From: Patrick Medland <PMedland@Geosyntec.com>
Sent: Tuesday, April 17, 2018 4:33 PM
To: Ackerman, Joyce; Stovall - CDPHE, Curtis
Cc: Dave Folkes; Jonathan H. Steeler; Richard Dean
Subject: RE: Neuhauser Landfill - AOC
Attachments: fig1_excavations_stockpiles.pdf

From: "Stovall - CDPHE, Curtis" <curtis.stovall@state.co.us>
Date: April 16, 2018 at 7:53:32 AM MDT
To: "Ackerman, Joyce" <Ackerman.Joyce@epa.gov>
Cc: Jason King <Jason.King@coag.gov>, "Walker - CDPHE, David" <david.walker@state.co.us>, "MacGregor - CDPHE, Kelly" <kelly.macgregor@state.co.us>
Subject: Re: Neuhauser Landfill - AOC

Neuhauser Landfill Site
Erie, Colorado

Excavations and Stockpiles

Figure 1
DE0302

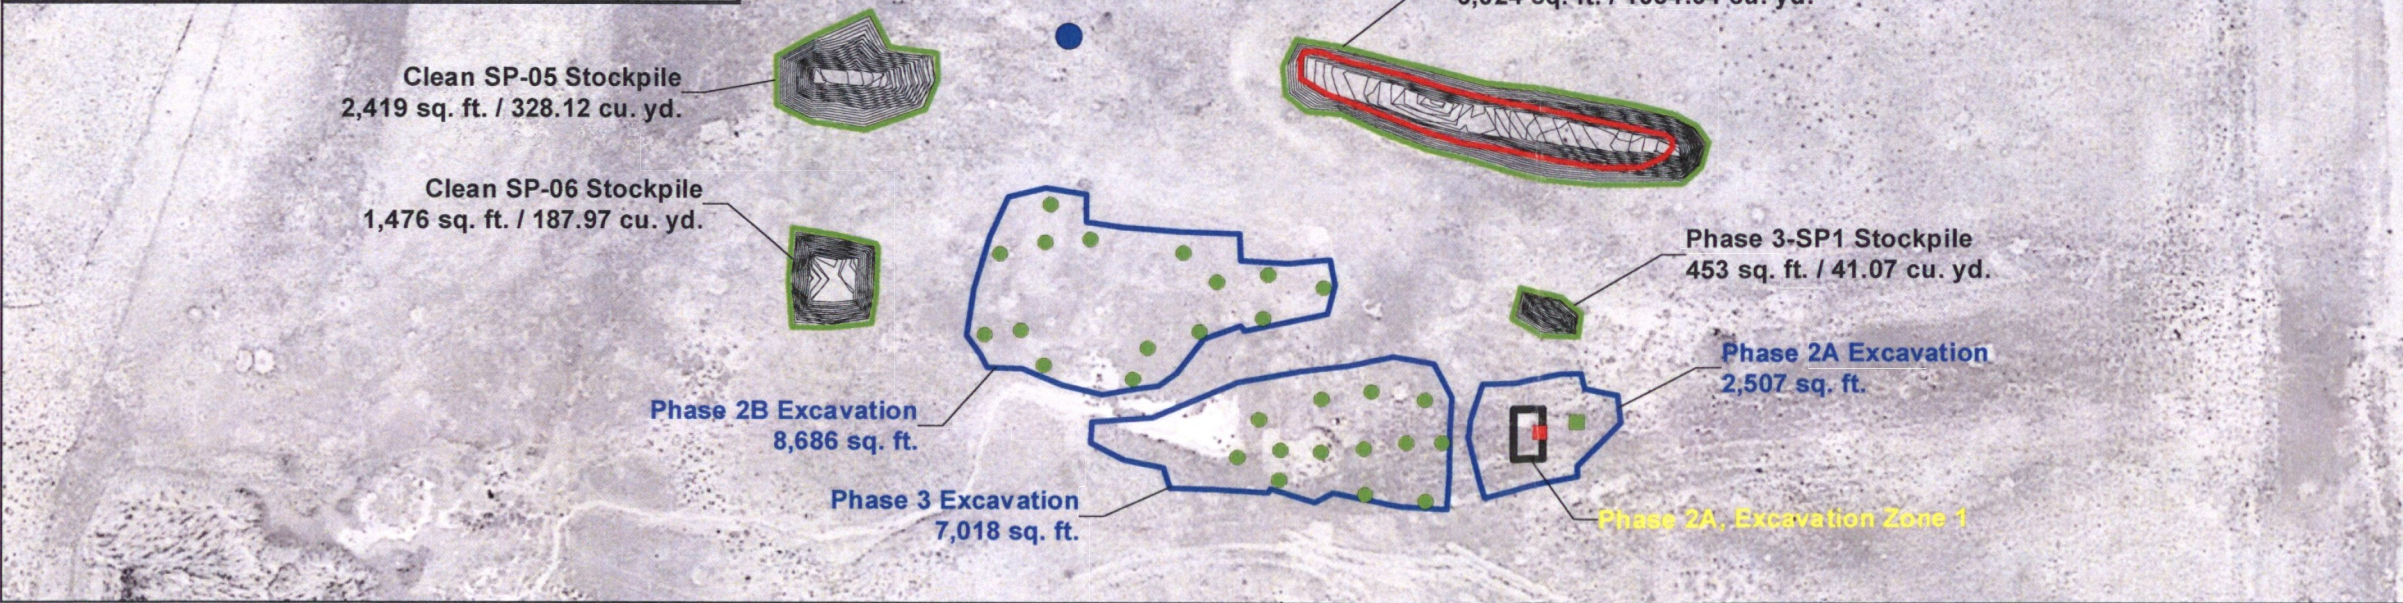
Comment 1: The excavation limits shown on the attachment are essentially the same as the excavation limits shown on a Figure that Geosyntec provided to us via email on February 23, 2018, with one exception. The Phase 2B limits shown on Feb. 23 figure are actually larger than limits shown on the April 13 version. The rectangular portion of the Phase 2B excavation at the southwest corner is not shown on the April 13 figure. Why? Please note that the Feb. 23 figure states that the excavation limits are based on a survey completed by CWC on February 17, 2018.

Comment 2: Based on the descriptions and photographs in the daily reports, it appears that the Phase 3 excavation was enlarged after the February 17 survey. Any enlargement of the Phase 3 excavation after February 17 is not reflected in the April 13 figure.

Comment 3: The daily reports indicate that the Phase 1 excavation was enlarged after February 17th (drum removal under the access road). This Phase 1 excavation enlargement is not reflected in the April 13 figure.

Comment 1 – The excavation limits from the February 17, 2018 survey included an area that was ramp built so an excavator could dig a test pit in the southwest corner of the Pit 2B excavation. The rectangular section referenced in the comment was that ramp, which was subsequently backfilled. A new survey of Pit 2B was conducted on March 2, 2018. Since this ramp was not a part of the drum removal excavation, it was excluded in the current draft map.

Comment 2 – I agree with your comment. I believe the February 17 survey data was mistakenly used in place of the March 2 survey data in this draft figure. I have attached a new figure with what I believe to be the correct survey boundaries for the Phase 3 excavation. I will verify tomorrow when I am out at the site.

Comment 3 – I do not believe the Phase 1 excavation was enlarged after February 17 and believe the current survey boundaries are correct. There were drums removed below an access road off the northwest corner of the Phase 2B excavation on February 22, 2018. These drums were not within the Phase 2B boundary and the Phase 2B excavation boundary was not enlarged due to this removal.
